Access Compliance Report

Public Rights-of-Way

(Curb Ramps)

Intersection ID: 13118	Main Street: E_7TH_ST	Cross Street: CENTRAL_AV	Location: N
ADA ID: 0DB6A45AE625	Ramp Type: PerpDiag	Initial Pass/Fail: Fail	Overall Compliance: No
			Severity Score: 33.75

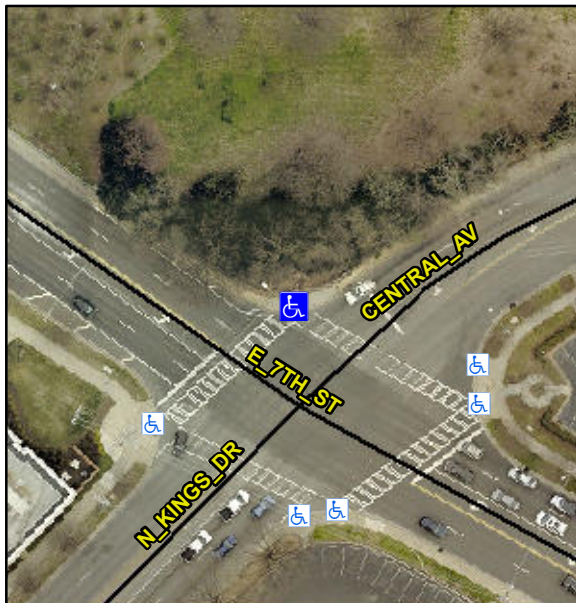
Not Found, R304.5.1, R304.2.2, R304.5.3

Compliance	Description	Data	Compliance	Description	Data
N/A	Ramp Length (in)	64.0	No	Ramp Slope (%)	8.7
No	Ramp Width (in)	47.0	No	Ramp XSlope (%)	5.6
N/A	Flare Type LT	N/A	N/A	Flare Type RT	N/A
N/A	Flare Slope LT (%)	N/A	N/A	Flare Slope RT (%)	N/A
N/A	Flare Traversable LT?	N/A	N/A	Flare Traversable RT?	N/A
N/A	Landing Length (in)	N/A	N/A	DWS Provided?	N/A
N/A	Landing Width (in)	N/A	N/A	DWS Contrast?	N/A
N/A	Landing Slope (%)	N/A	N/A	DWS Length (in)	N/A
N/A	Landing X Slope (%)	N/A	N/A	DWS Full Width?	N/A
N/A	Landing Curb? (Y/N)	N/A	N/A	DWS Offset (in)	N/A
N/A	Shared Landing?	N/A			
N/A	Gutter Ponding?	Yes	N/A	Gutter Slope (%)	N/A
N/A	Gutter Lip Ht (in)	N/A	N/A	Gutter X Slope (%)	N/A
N/A	Painted X Walk1?	Yes	N/A	Painted X Walk2?	Yes
	X Walk 1 Direction	To SW		X Walk 2 Direction	To SE
N/A	X Walk 1 Width (in)	110.0	N/A	X Walk 2 Width (in)	110.0
	X Walk 1 Slope (%)	0.0		X Walk 2 Slope (%)	5.6
	X Walk 1 X Slope (%)	5.2		X Walk 2 X Slope (%)	0.7

Remove & Replace Curb Ramp With Two New Directional Ramps or Equivalent.
